## APPEAL SUMMARY

**Status:** Decision Rendered**Appeal ID:** 15833**Project Address:** 817 SW 17th Ave**Hearing Date:** 9/13/17**Appellant Name:** Michelle Schulz**Case No.:** B-016**Appellant Phone:** 503-548-2379**Appeal Type:** Building**Plans Examiner/Inspector:** Kathy Aulwes**Project Type:** commercial**Stories:** 9 **Occupancy:** B, M, A **Construction Type:** 1-B**Building/Business Name:** Press Blocks - Half Block Office**Fire Sprinklers:** Yes - Throughout**Appeal Involves:** Erection of a new structure**LUR or Permit Application No.:** 17-182179-CO**Plan Submitted Option:** pdf [File 1] [File 2] [File 3]**Proposed use:** Office with ground level retail

Opening Protectives  
Appeal

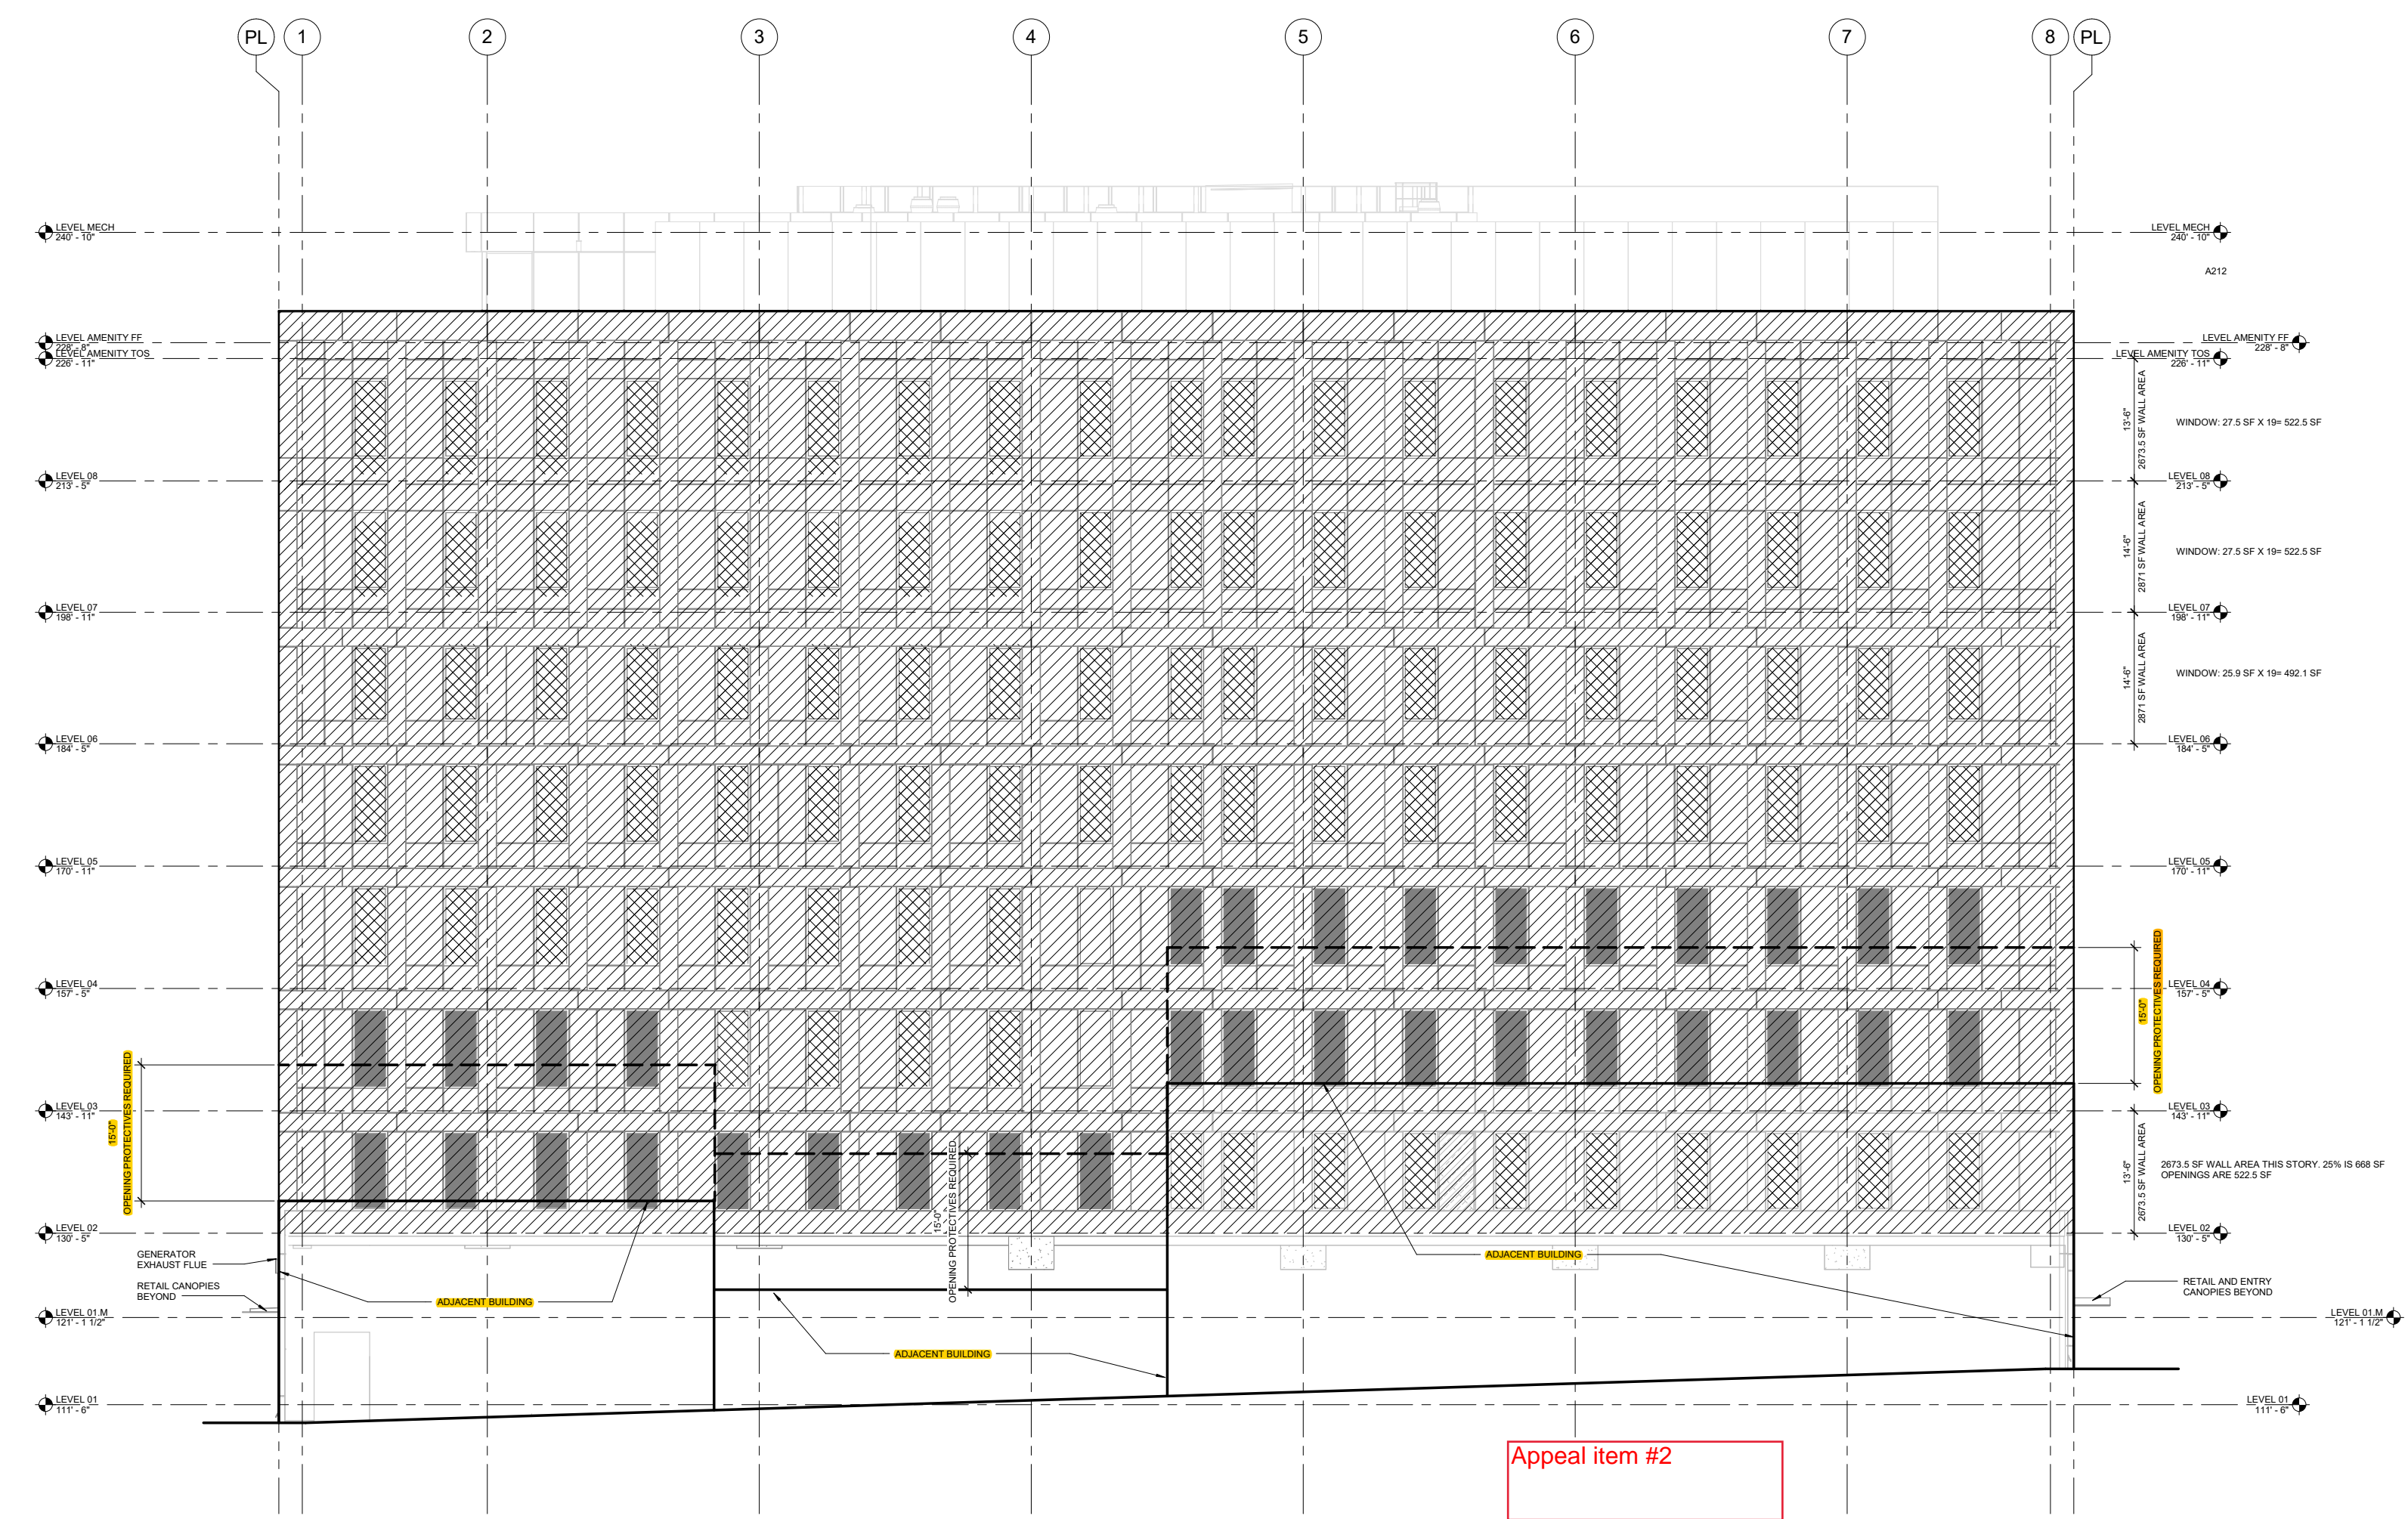
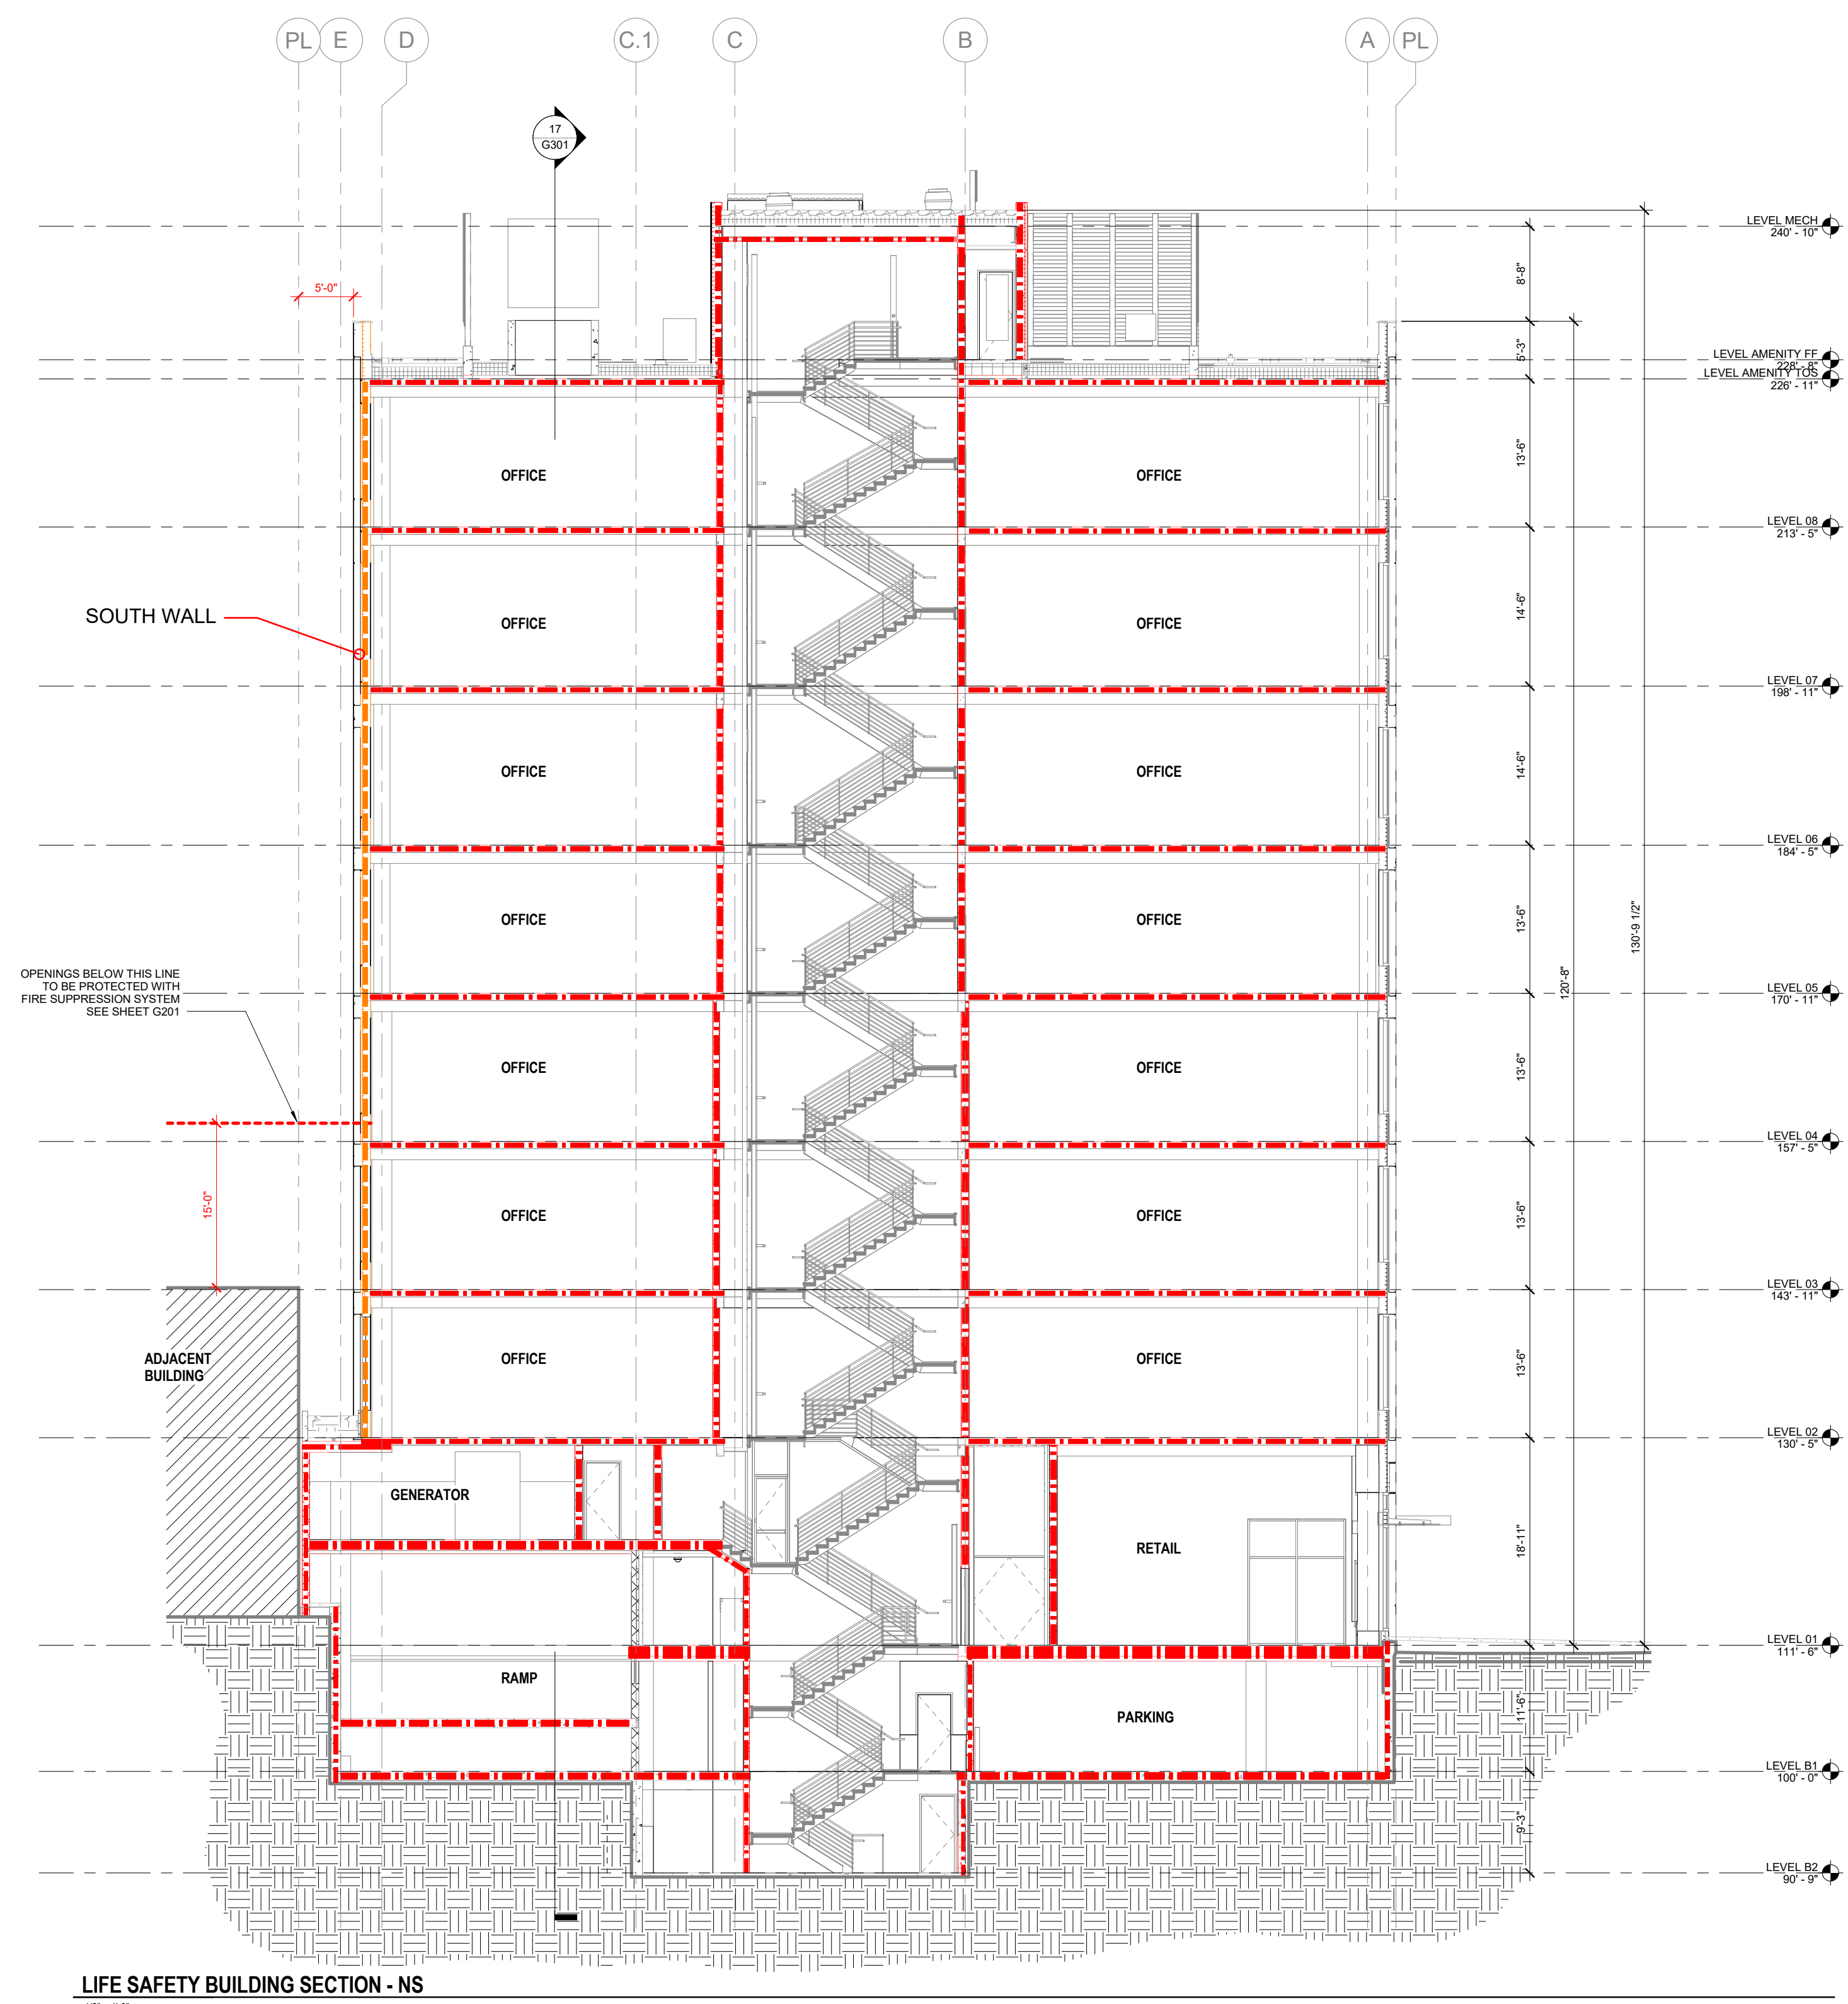
In lieu of the required 3/4-hour protection at the window openings on the north and south elevations at the 2nd, 3rd and 4th floors within 15 feet of the adjacent building, the openings are to be protected with sprinkler heads which are to be installed a minimum of 4 inches and a maximum of 24 inches from the openings and spaced at 6 feet on center or closer. Sprinklers are to be installed on the occupied side of the openings.

See EX-1 - Opening Protective Appeal for window locations.

**Reason for alternative** The building is Type 1B construction with non-combustible exterior finish materials and is fully sprinkled with a full NFPA 13 sprinkler system. Standard fire sprinkler heads can be designed and installed to provide an equivalent degree of protection at the window openings within 15 feet of the adjacent building. The windows provide daylight and views to occupants of the building, which support a healthy interior environment. The proposed design meets the intention of the code to provide fire protection between the new building and the existing adjacent building. All openings for the new building comply with Table 705.8 regarding allowable area relative to fire separation distance.

**2. Sprinkler protection at openings in buildings with vertical exposure on separate lots: Granted provided windows are non-operable and sprinklers are installed a minimum of 4 inches and a maximum of 24 inches from the opening(s) spaced at 6 feet on center. Sprinklers are to be installed on the occupied side of the openings and shall be capable of wetting the entire surface. A separate permit from the Fire Marshal's Office is required.**
